COMPANY
NEERING
AW

MIT
WOEE
EST TO
CHANGES

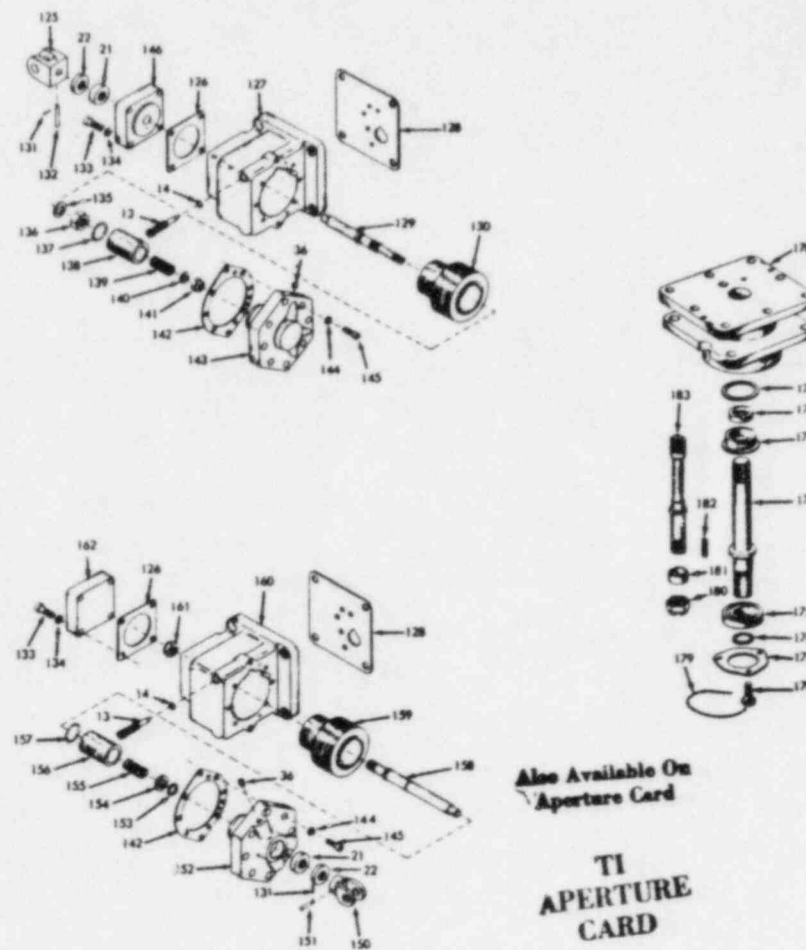
BULLETIN 36694B

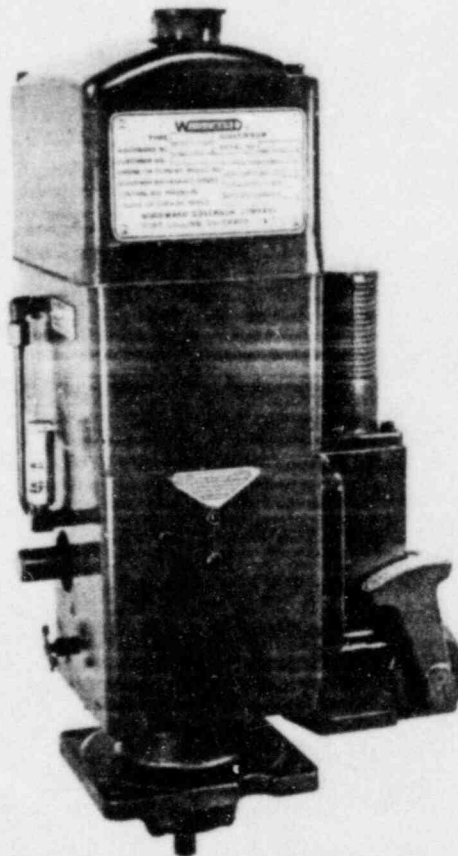
(REPLACES BULLETIN 36012)

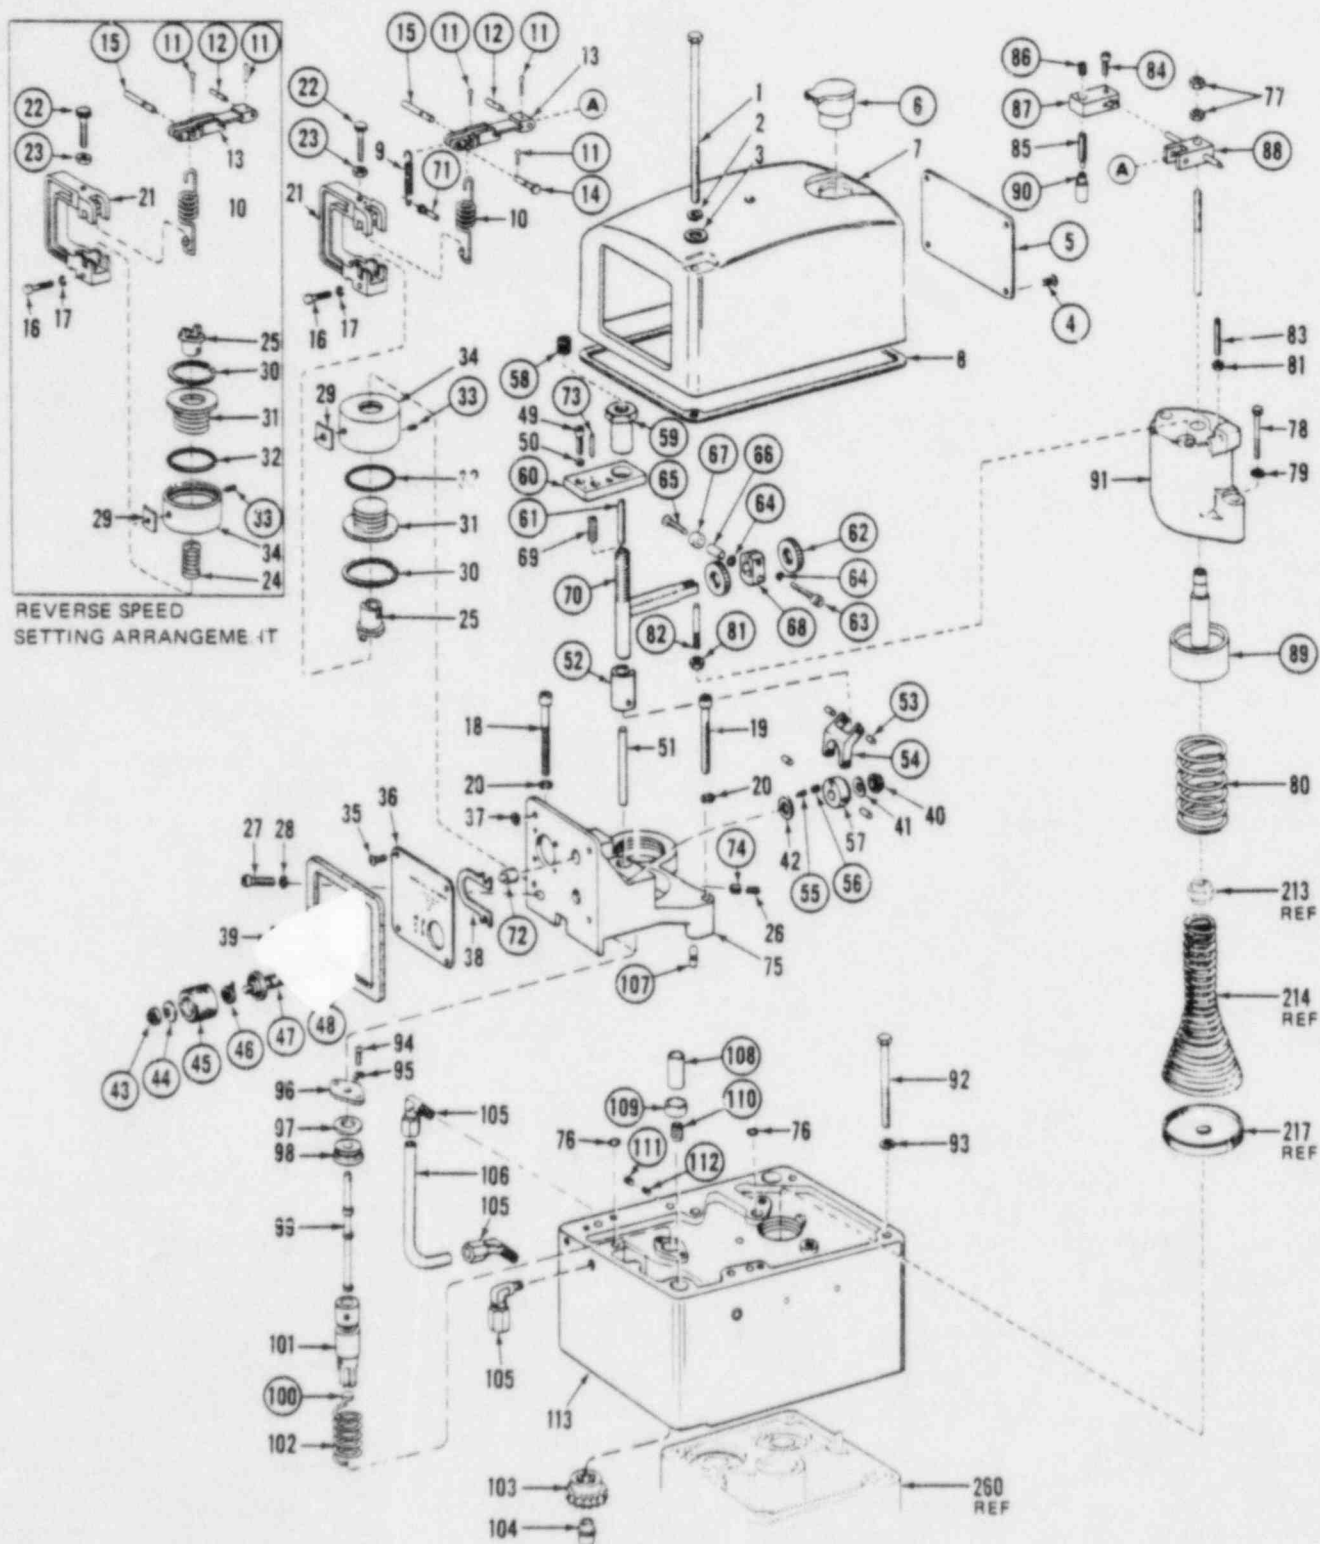
REF. NO.	PART NAME	NO. REQ'D	REF. NO.	PART NAME	NO. REQ'D.
36694-201	Screw, soc. hd., 3/8-16 x 1 1/4	4	36694-231	Washer, lock, #5	8
36694-202	Washer, lock, 3/8	4	36694-232	Flyweight head sub-assembly	1
36694-203	Power cylinder assembly (refer to bulletin 36692)	1	36694-233	Retaining ring	1
36694-204	Gasket, power cylinder case	1	36694-234	Compensating bushing	1
36694-205	Screw, hex hd., 5/16-18 x 1	8	36694-235	Pilot valve plunger	1
36694-206	Washer, lock, 21/64	8	36694-236	Bearing	1
36694-207	Base assembly (refer to bulletin 36693)	1	36694-237	Oil seal ring	1
36694-208	Power case-base oil seal ring	1	36694-238	Flyweight head-bushing assembly	1
36694-209	Idler gear	1	36694-239	Retaining ring	1
36694-210	Idler stud	1	36694-240	O-ring	1
36694-211	Drive gear	1	36694-241	Plug	1
36694-212	Gasket	1	36694-242	Buffer spring	2
36694-213	Speeder spring check plug	1	36694-243	Buffer piston	1
36694-214	Speeder spring	1	36694-244	Buffer seat	1

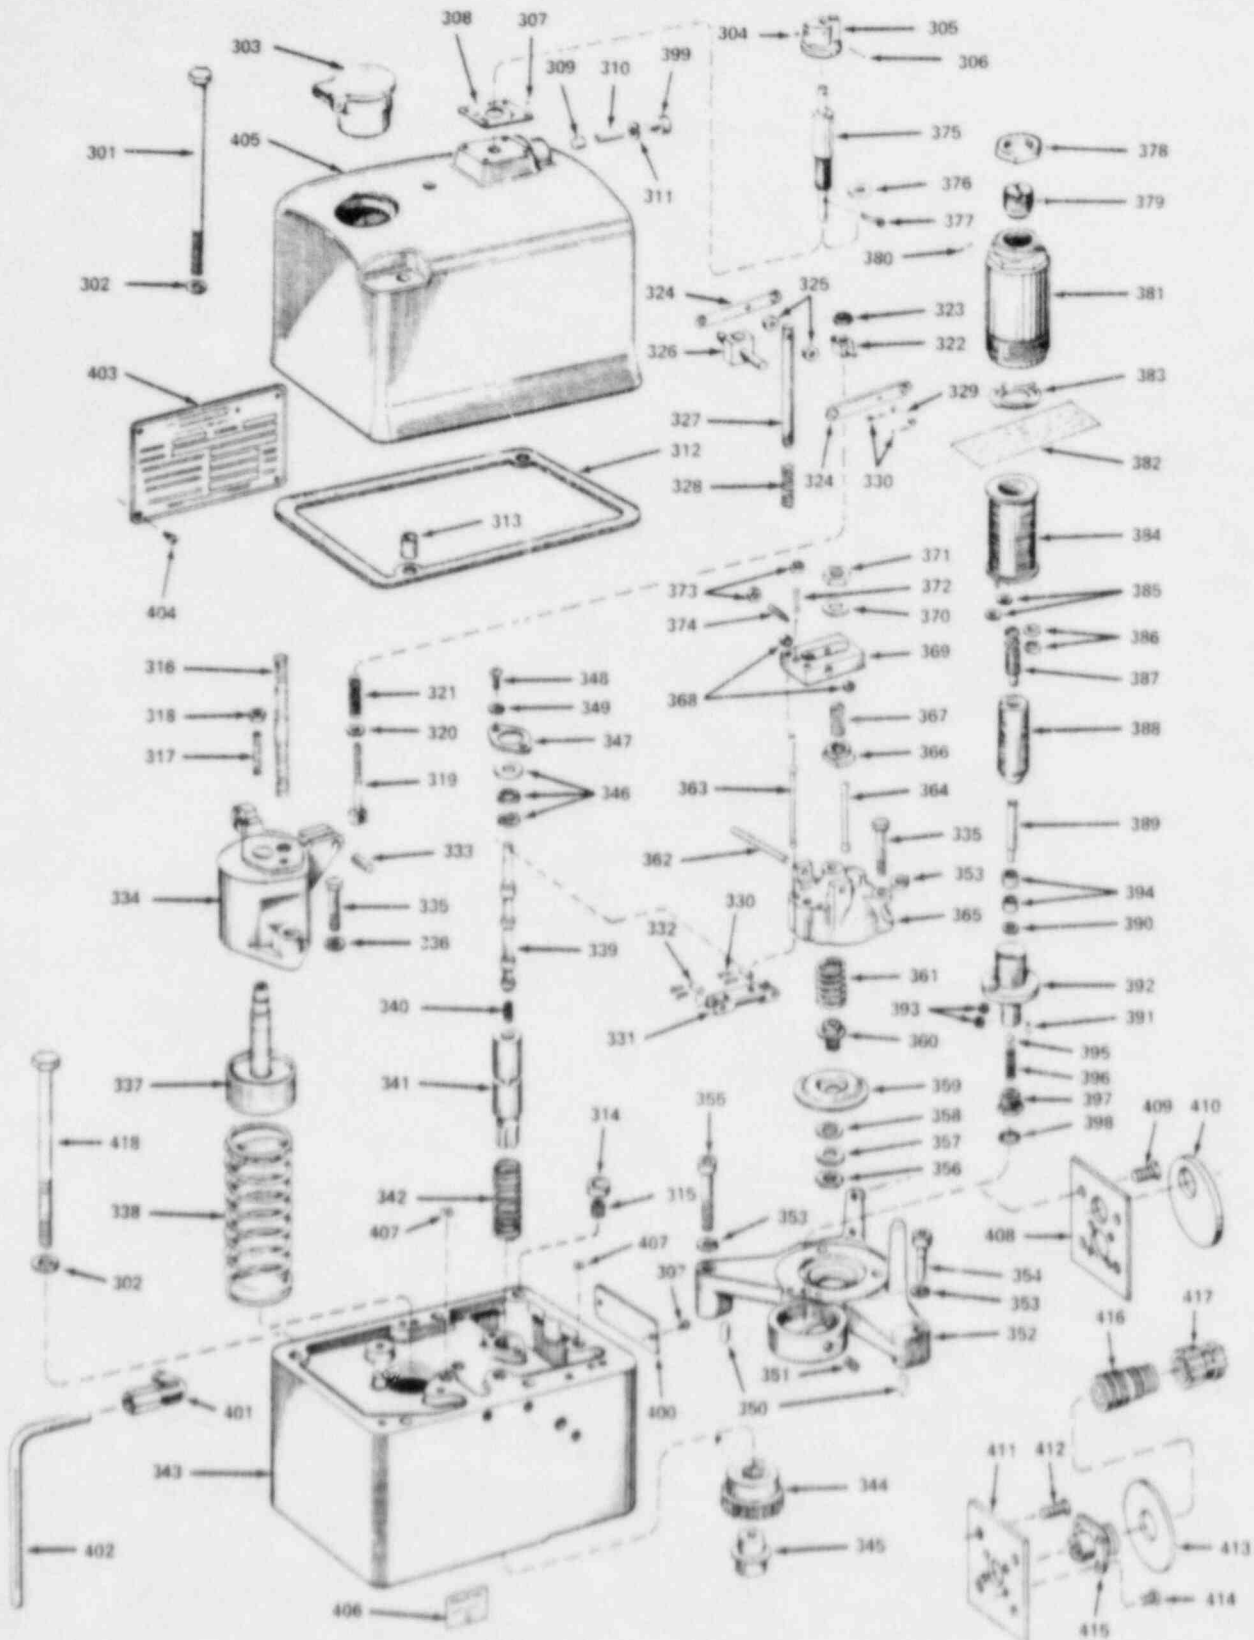
BULLETIN 36694C

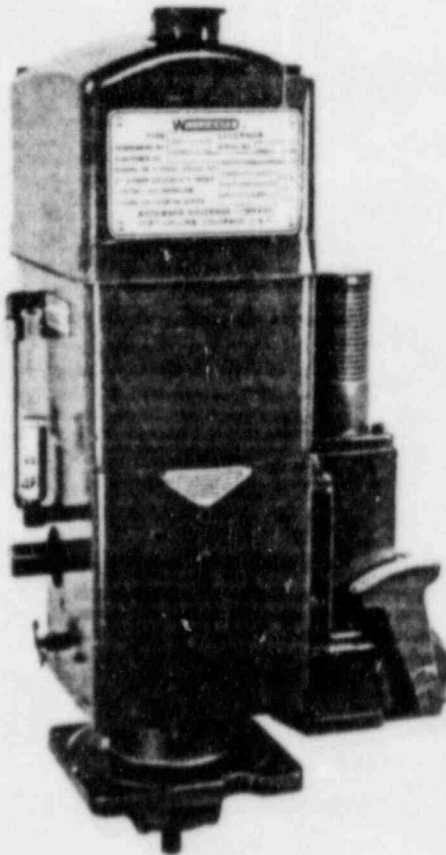
(REPLACES BULLETIN 36012)

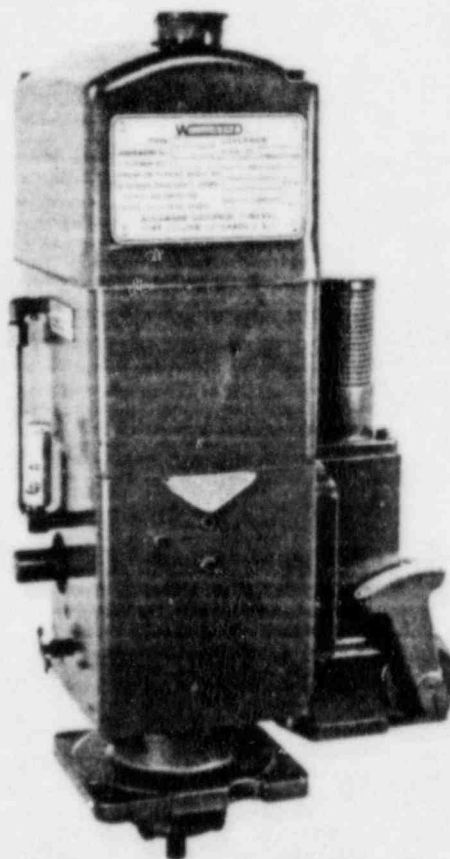
(REPLACES BULLETIN 36012)

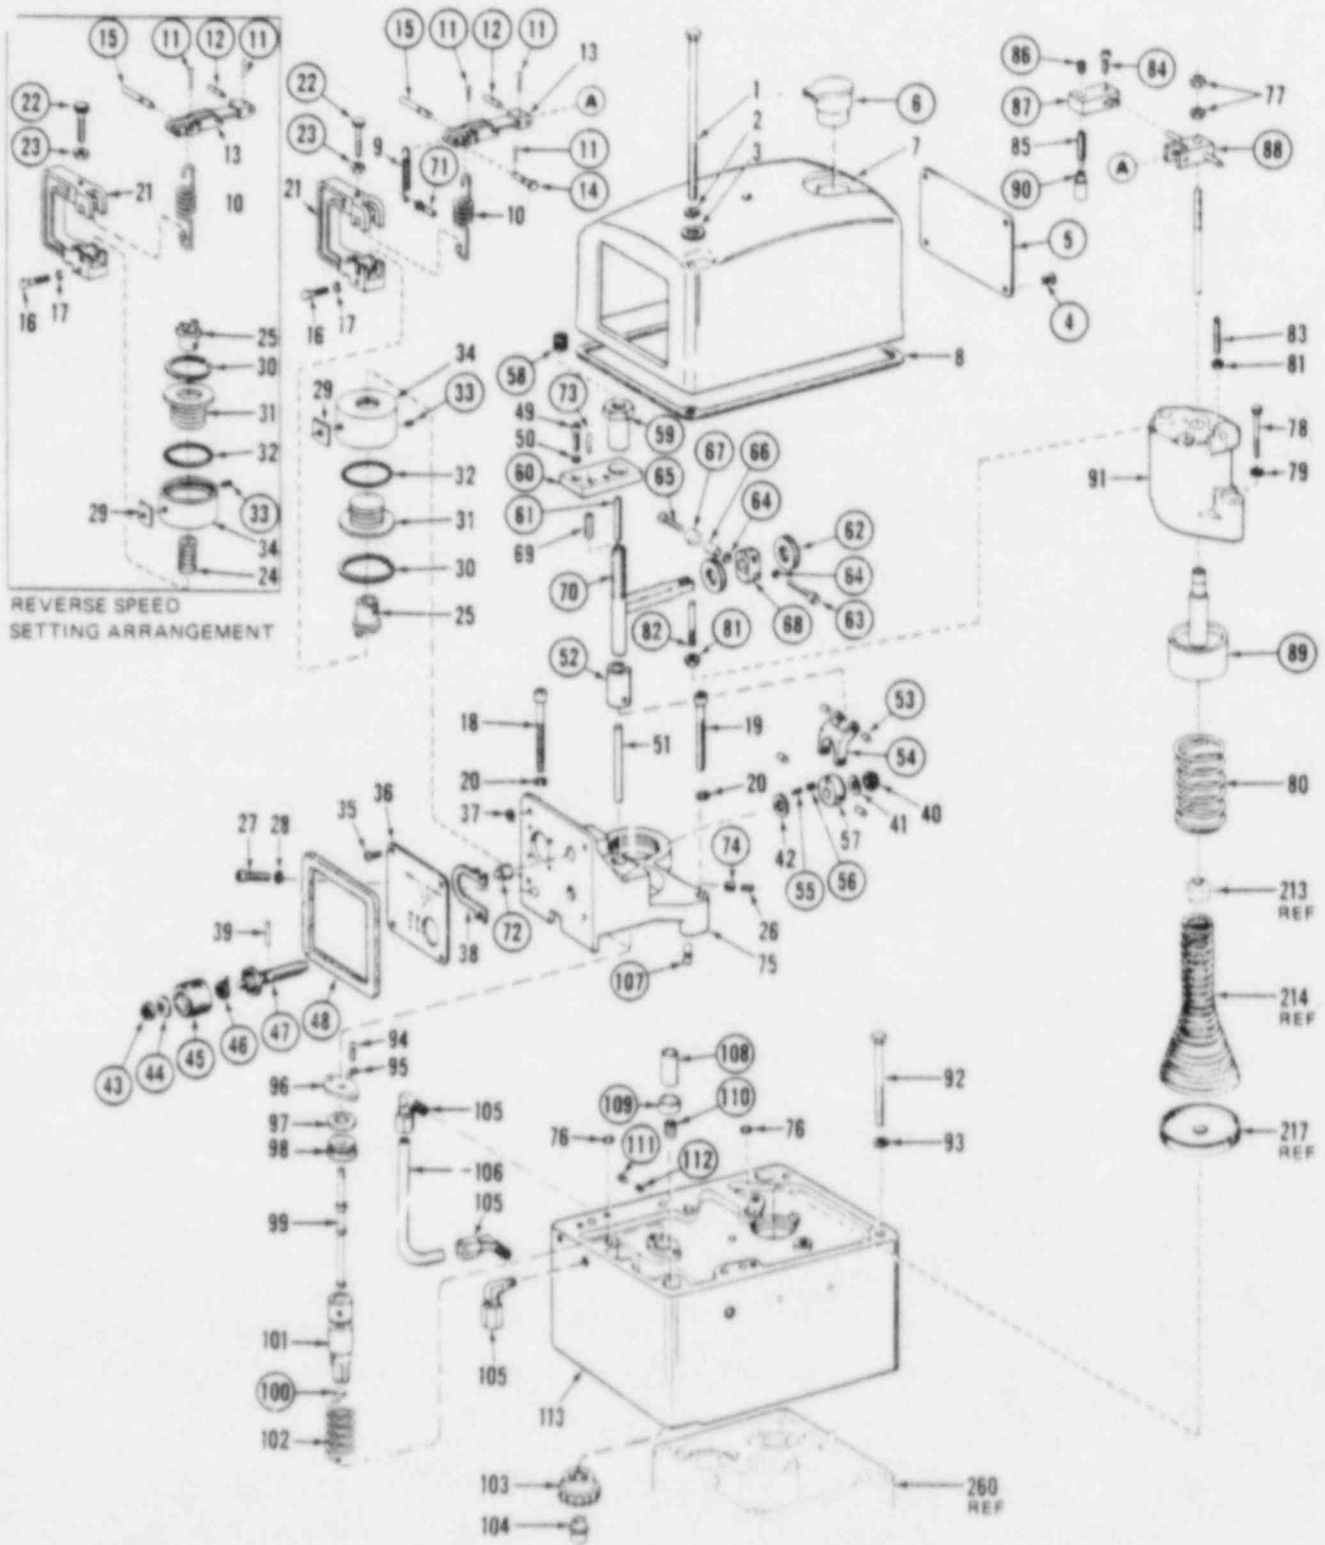
REF. NO.	PART NAME	NO. REQ'D	REF. NO.	PART NAME	NO. REQ'D.
36694-201	Screw, soc. hd., 3/8-16 x 1 1/4	4	36694-231	Washer, lock, #5	8
36694-202	Washer, lock, 3/8	4	36694-232	Flyweight head sub-assembly	1
36694-203	Power cylinder assembly (refer to bulletin 36692)	1	36694-233	Retaining ring	1
36694-204	Gasket, power cylinder case	1	36694-234	Compensating bushing	1
36694-205	Screw, hex hd., 5/16-18 x 1	8	36694-235	Pilot valve plunger	1
36694-206	Washer, lock, 21/64	8	36694-236	Bearing	1
36694-207	Base assembly (refer to bulletin 36693)	1	36694-237	Oil seal ring	1
36694-208	Power case-base oil seal ring	1	36694-238	Flyweight head-bushing assembly	1
36694-209	Idler gear	1	36694-239	Retaining ring	1
36694-210	Idler stud	1	36694-240	O-ring	1
36694-211	Drive gear	1	36694-241	Plug	1
36694-212	Gasket	1	36694-242	Buffer spring	2
36694-213	Speeder spring check plug	1	36694-243	Buffer piston	1
36694-214	Speeder spring	1	36694-244	Buffer seat	1
